Review of safety assessment in Posiva's construction license application for a repository at Olkiluoto

SAGAR Budhi [Southwest Research Institute] (ed.). Review of safety assessment in Posiva's construction license application for a repository at Olkiluoto. STUK-TR 19. Helsinki 2015. 92 pp + Appendices 12 pp.

The CLA consists of 14 Turva-2012 Portfolio Main reports and 7 Supporting reports (list can be viewed at pages 379–380 of Posiva 2012-09) and a much larger set of other references. STUK contractually assigned selected reports (or parts of reports) for review to various members of the review team. Workshops were held periodically at STUK offices where consultants could discuss each other’s review comments. Some workshops involved meeting with Posiva staff aimed at getting clarifications on certain selected topics. Based on consultant comments, STUK also sent written “requests for additional information (RAIs)” to Posiva.

Figure 1. Results for the base case scenarios. The figure (a) shows the normalized release rates and the figure (b) shows the annual doses to representative persons within the most exposed group.

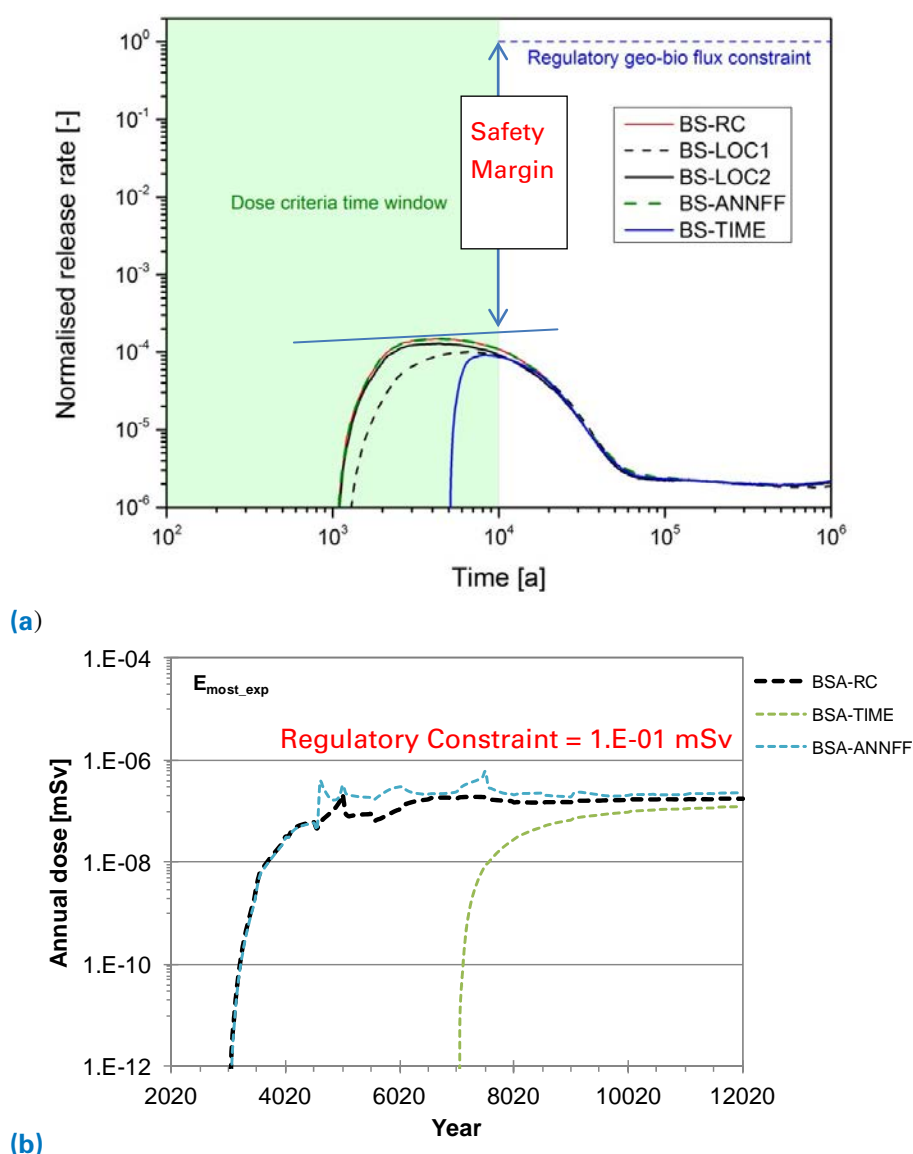
these figures, the maximum normalized release rate of approximately 10^{-4} occurs at about 3,000 years. Results of all calculation cases are similar except for the BS-Time [blue curve in Figure 1(a)] where the transport resistance of the defect is lost in 5,000 years instead of in 1,000 years in the BS-RC. Figure 8-2, page 187, Posiva 2012-12, not reproduced here, shows that there is little difference between the release rates at the near-field and far-field boundaries. Most of the release is made up of C-14, I-129, and CL-36 which are non-sorbing radionuclides with unlimited solubility. This means that the far-field rock's contribution to mediation of radionuclide transport is minimal. Of course,

let us not forget that the far field rock does provide a safe environment for the EBS. Figure 1(b) shows the dose to the representative person in the most exposed group. The peak annual dose is estimated to be less than 10^{-6} mSv compared to the regulatory constraint of 10^{-1} mSv. It is apparent that under the “expected” evolution of the base scenario, the system is designed to have a large amount of safety margin – a factor of 10^5 better than the dose safety standard and a factor of 10^4 better for the normalized release standard. We have raised some questions about both the geosphere and the biosphere assessment and those should be clarified but it is clear that, at least for this scenario, there is no possibility of exceeding the regulatory dose standards.

(4) *Results in Figure 8-2, page 187, Posiva 2012-12 shows that the contribution of the far-field rock in delaying or attenuating the releases to the biosphere is minimal (although obviously the far field rock provides "safe environment" for the engineered barriers); therefore, relatively more resources should be spent on evaluating the performance of the near-field rock and the EBS.*

Figure 2. Results of variant scenarios; (a) shows results for VS1 and (b) for VS2. [Adapted from Figure 8-8 (a), page 198 and Figure 8-9, page 201, Posiva 2012-12]

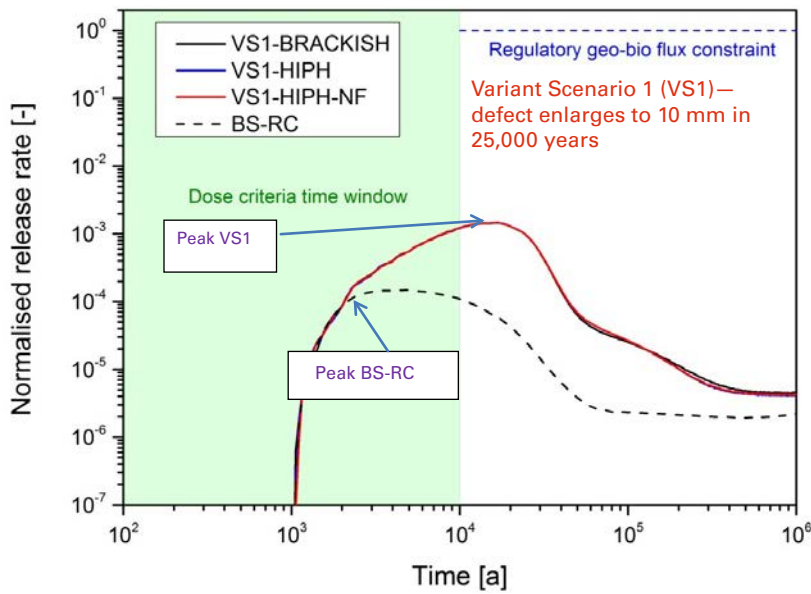
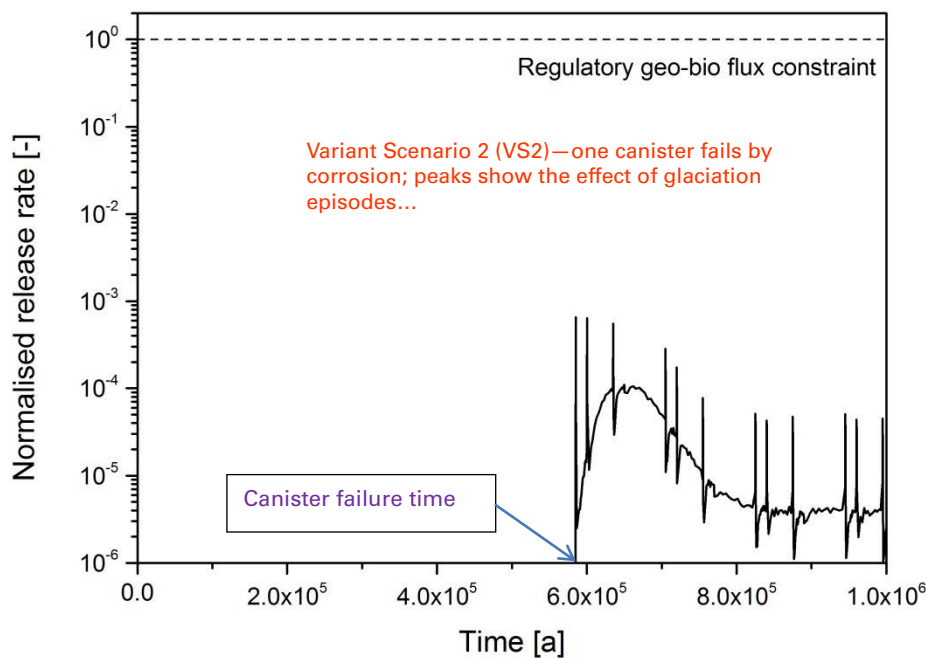
Figure 2(a) shows a peak annual normalized release rate approximately an order of magnitude higher than obtained in the base scenario. The time of occurrence of the peak is controlled by the time at which the defect grows to 10 mm size which is 25,000 years (that is greater than the dose time window and therefore does not affect dose calculations). The calculated dose is shown in Figure 8-10, page 202, Posiva 2012-12 (not reproduced here). In this figure, the peak annual dose to the most exposed representative is shown to be about 10^{-4} mSv. Of greater interest is that the peak dose depends on the location of the failed canister and the resulting discharge location estimated from the use of the DFN model (the highest peak dose is estimated for discharge locations south of the repository). Figure 2(b) shows reoccurring narrow peaks due to rapid flushing of non-sorbing radionuclides (primarily I-129 but also CL-36 and Se-79) from the geosphere during high flows at times of ice age retreats. Based on these results for one failed canister, Posiva asserts on page 200, Posiva 2012-12, “... release rates calculated for a single failed canister in scenario VS2 indicate that the few canister failures that could potentially arise in a more likely lines of evolution could easily be tolerated...” There is some inconsistency in the use of terms in Posiva documents. For example, as just stated if “a few” failed canister is a “likely” evolution then that should be defined as the reference case or the variant case. The depth to which dilute water may penetrate

and the numbers of canisters that may be affected depend on the results of the DFN model. We know that the water travel time in fractures calculated in the DFN model is relatively low; therefore, the above results will be sensitive to the time for which the source of dilute water is allowed to exist. The discharge locations (not so much the timing of the discharge) on which the annual dose depends also is determined by the DFN model. This is further discussed in the next section on disturbance scenarios. To build confidence in the safety case, Posiva should consider conducting a PSA of this case.

Note also that in both Figures 2(a) and 2(b), the highest annual normalized release rate is approximately 10^{-3} . Although strictly not true, one could guess from this result that at least 1,000 canisters either have to have large defect (large enough to have advective transport) or fail by some other process (e.g., corrosion or rock shear) for the release rate to exceed the regulatory constraint.

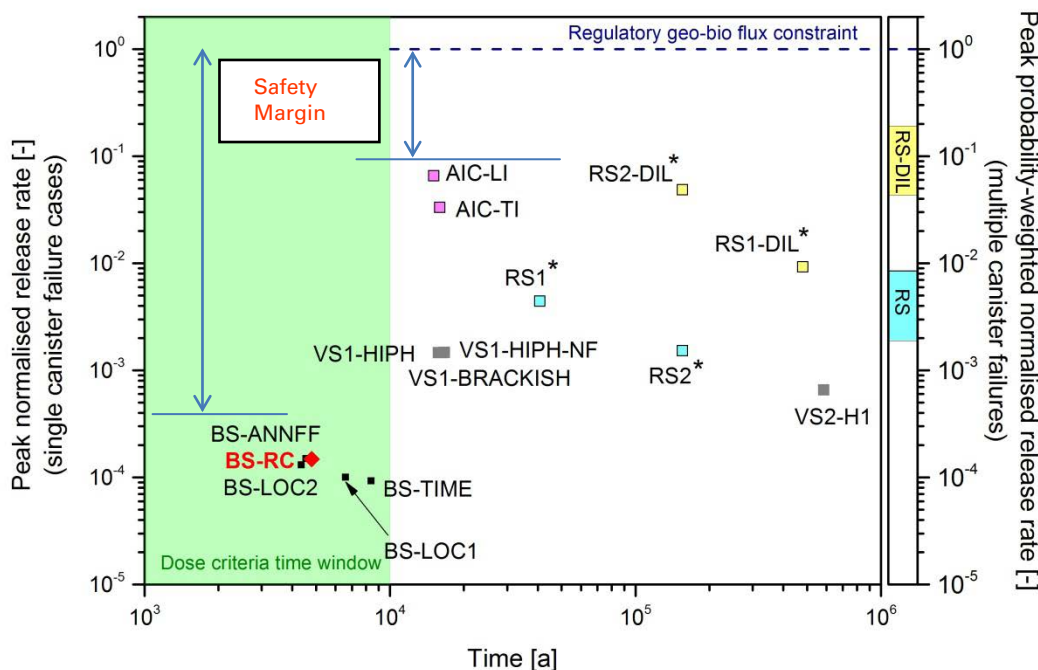
Figure 3 shows that the AIC and the RS-DIL scenarios produce the highest expected peaks of normalized release (see Appendix A for probabilistic sensitivity analysis for RS-DIL). The safety margins during the dose time window and the longer period are also marked with blue arrows. Posiva considers

the possibility of these two scenarios occurring together. The results presented in Figure 15-3, Posiva 2012-09 show that the peak releases from the AIC scenario dissipate long before the peak release from the RS scenario occurs. Note the significant reduction in the safety margin for the disturbance scenarios.

The CLA demonstrates that Posiva has a good understanding of the role of scenarios in demonstrating compliance with STUK's safety regulations. Figure 3 of this report shows results of all the scenarios. Note that the results for the disturbance scenarios are probability weighted as is allowed by STUK regulations (YVL D.5 §316). The figure summarizes the Posiva conclusion that the proposed repository at Olkiluoto will comply with the safety standards.

As can be seen in Figure 3, the Base Scenario releases are more than three orders of magnitude smaller than the regulatory limits specified in GD 736/2008 4 §. Note that only in the RS scenario (RS in the figure), does Posiva apply the 1,000-year

Figure 4. Results of an independent calculation conducted by a member of the core review team showing the effect of multiple failed canisters emplaced in deposition holes with either 'average' water inflow rates or 'pessimistic' water inflow rates.

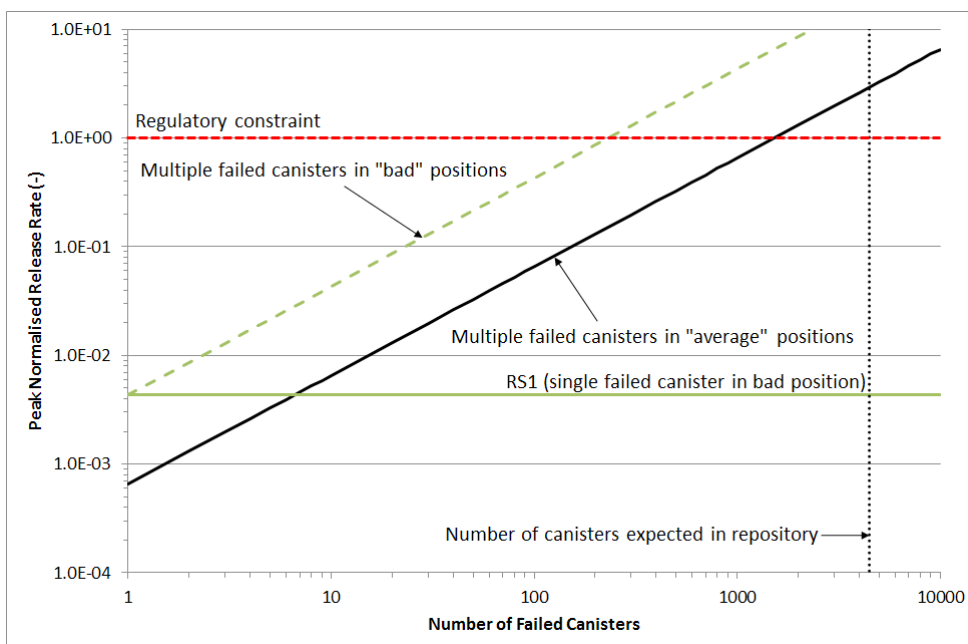
a computer code different from Posiva's suite of codes. This calculation assumes that the seismic event occurs at 40,000 years. The results of this calculation are shown in Figure 4. Assuming failed canisters are emplaced in average deposition holes (relative to water inflow rates) the number of canisters that has to fail to exceed the annual NRR is greater than 1,000. However, if the flow assumption is changed to those assumed in the BS-RC case, the number of canister that has to fail to exceed the regulatory constraint is only about 200.

These results points to the importance of near-field flows once a canister has failed; greater the inflow to a deposition hole with a failed canister, greater is the radionuclide source term. This analysis still does not correlate higher inflow rates to canister failures. In the above analysis, canisters were assumed to fail due to rock shear. Posiva has estimated that at most 78 canisters can fail in a severe earthquake scenario and not all of these will face the flow conditions of BS-RC. Another independent calculation conducted by the same review team member shows that a large number of canisters can be impacted by dilute water if the post-glacial infiltration period is say 1,000 years

This independent analysis provides confidence that the repository system proposed by Posiva is reasonably robust.

Figure 7. Mean ranks of all (162) random parameters in 1,000 realisations that have the largest normalized release rate (the red curve) and also 1,000 realisations with the lowest (the blue curve) normalized release rate of I-129. [Reproduced from Figure 4-3, page 49, WR 2013-25]

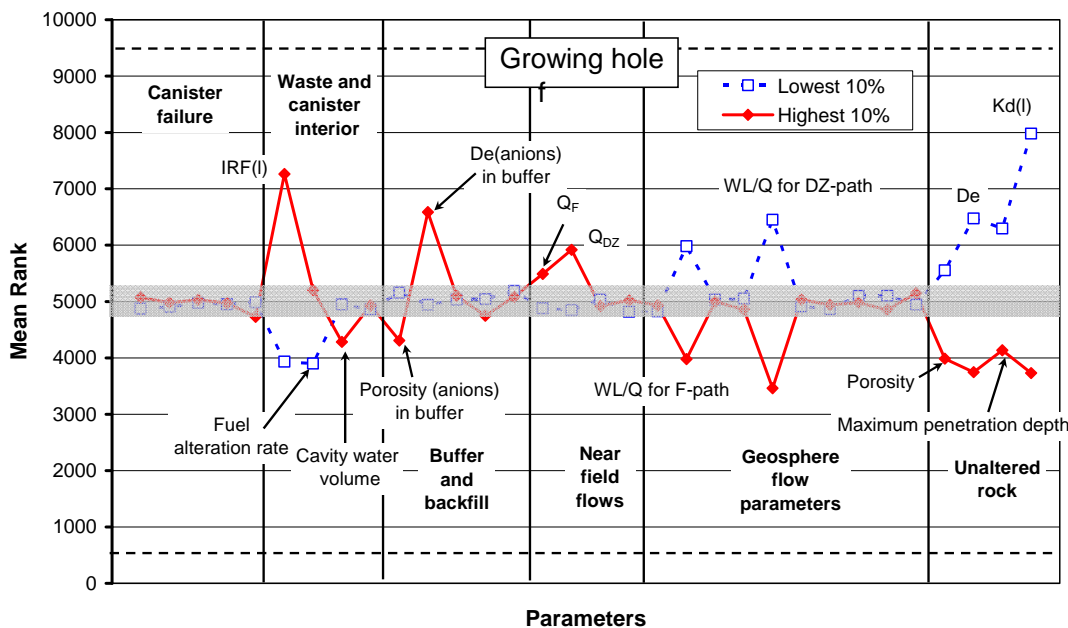
From the red curve in Figure 7, we can conclude that for the growing hole case, high values of instantaneous release fraction, IRF (I), diffusion coefficient, D_e (anions) in buffer, near-field flow rate in the damaged zone, Q_{DZ} , and near-field flow rate

There are two apparent surprises in results of Figure 7: (1) none of the parameters related to canisters appear among the important and (2) fuel alteration rate does not appear to affect the peak normalized release at the geo-bio boundary. It is easy to understand why none of the canister parameters show up as important: the canisters, except for the initial defect in one, never fail. Having canisters that maintain containment for a long period is a positive attribute of the Posiva design. However,

use of such a dominant barrier makes it difficult to understand the performance (or capability) of other barriers. It may be worthwhile for Posiva to consider some analysis to show the capability of individual barriers. A “one-off” analysis may provide important information in this regard. To figure out the reason for the fuel alteration rate not showing up as important in Figure 7 may require some additional thought. Also, the non-zero value for K_d in unaltered rock (far-field) for I-129, albeit small makes the highest contribution to realizations with low peak normalized release. It is interesting to note that K_d for I-129 in the buffer is fixed at zero in the PSA (Table 3-11, page 25) otherwise none of it will likely show up in the far-field.

Figure 9. Estimated maximum annual dose to a representative of the most exposed group in the nine cases described in the safety case. [Adapted from Figure 8-19, Page 219, Posiva 2012-12]

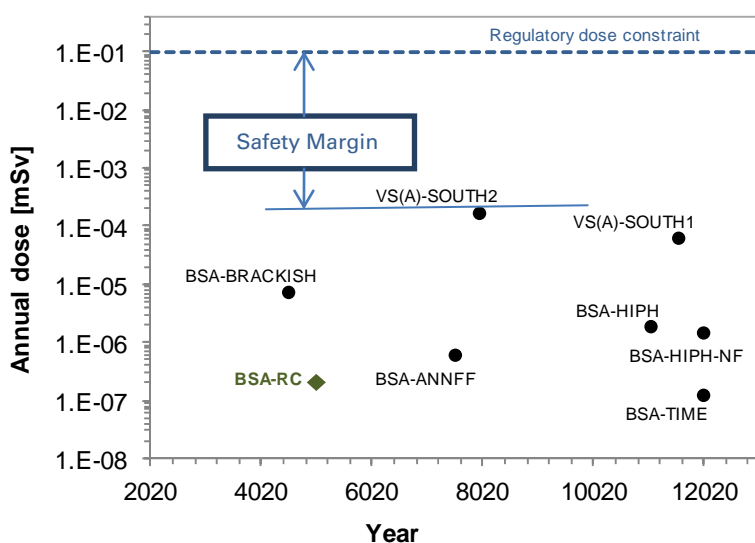
The annual dose maxima for a representative in the most exposed group are provided in Figure 9. This figure shows that, in a relative sense, the discharge points determined by the DFN model can have a significant effect on the estimated dose but the dose is so far below the regulatory limit that it doesn’t matter in the absolute sense because the probability of it exceeding the limit is quite low. A scoping calculation conducted by a member of the review team indicated that alternate assumptions can lead to dose estimate that is 10 times the

Figure 11. Radionuclide dose contribution in the human intrusion scenario occurring at 1,000 years; Cs-135 and Sr-90 can be expected to make major contributions if the event is assumed to occur say at 200 years. [Adapted from Figure 8-14, page 208, Posiva 2012-12]

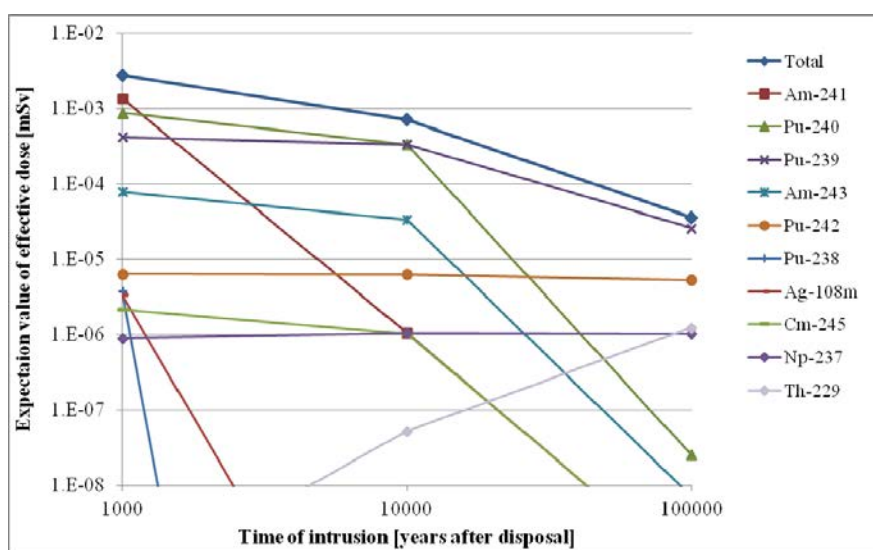
The results for the human intrusion scenario are provided in Figure 8-14 on page 208 of Posiva 2012-12 and reproduced below. Note that the dose values in this figure are expected values meaning that Posiva has multiplied the calculated dose by the probability of intrusion (drilling). This is allowed by Posiva regulations.

are assessed but the results are not presented in that report. We note that human intrusion might lead to chronic radionuclide releases, in addition to acute releases/exposures associated with the intrusion event. For example, chronic exposure may result from groundwater flow and radionuclide transport up an abandoned, open, site investigation borehole, or due to a contaminated abandoned drill site. Such chronic effects have not been assessed by Posiva.

Figure A.2. Cumulative probability distributions of normalized release rates for the three emplacement holes with defective canisters.

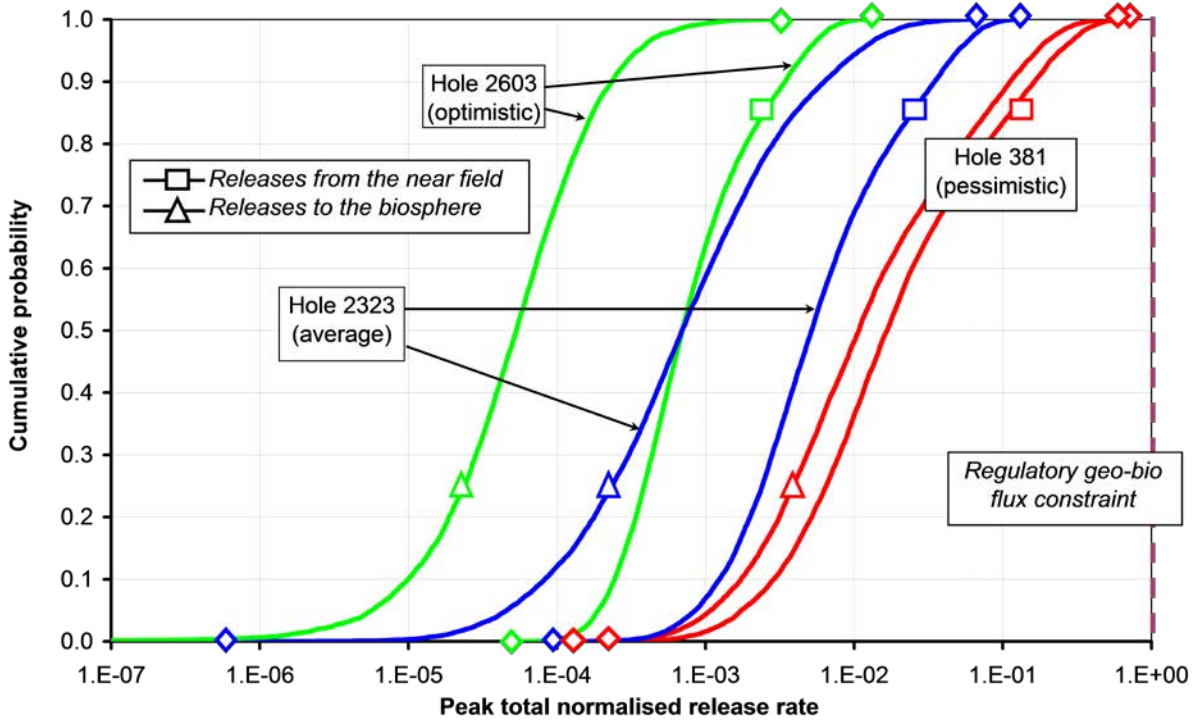
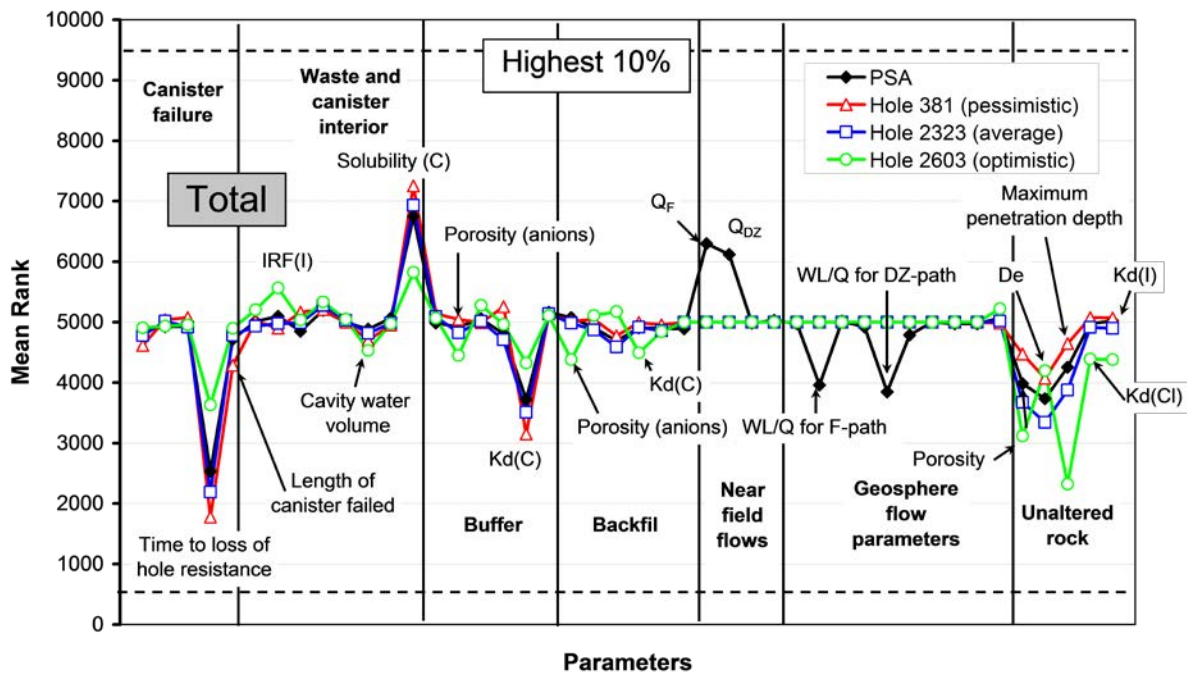
Two points to be noted in Figure 2 are (1) the peak normalized release rate can vary three orders of magnitude depending on the location of the emplacement hole and (2) the contribution of the far field increases as one moves from the pessimistic to the optimistic hole. The figure showing the mean parameter ranks is also reproduced below.

From this figure, we note that most of the sensitive parameters are the same in the three cases except for the high importance of matrix diffusion in the case of optimistic location (green line). This can be easily explained as in cases with higher flow rates, matrix diffusion in the far field will play an important role in lowering the peak. The other interesting result is that certain parameters (QF, QDZ, WL/Q for the F and the DZ paths) that were identified as important in PSA when defective canister location was also sampled; don’t show up as important in either of the three cases. None of this show up as important when mean parameter ranks is plotted for individual radionuclides. This could be the result of reduction in variation of these parameters due to a fixed deposition hole location but a more complete explanation needs to be developed. Overall, Posiva has produced significant

Figure B.1. Number of deposition holes (y-axis) and saturation time (x-axis).

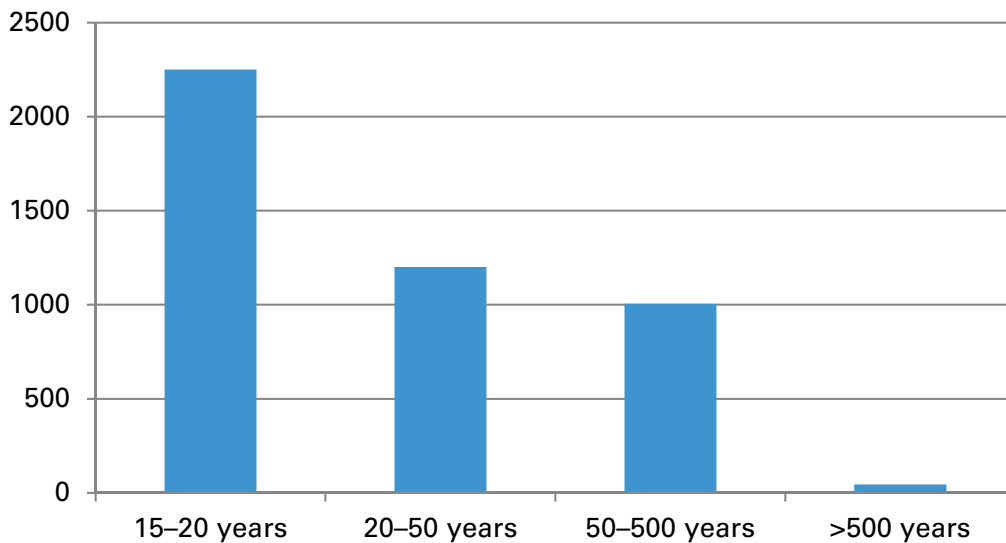
A much larger number, in hundreds, may see a saturation time of the order of 500 years.

Posiva admits to significant uncertainties in the above estimates, the major one being that the hydraulic conductivity of intact host rock is not well known and it is that source of water that is expected to cause long saturation times. Posiva should device a method to measure this parameter at the beginning of construction.
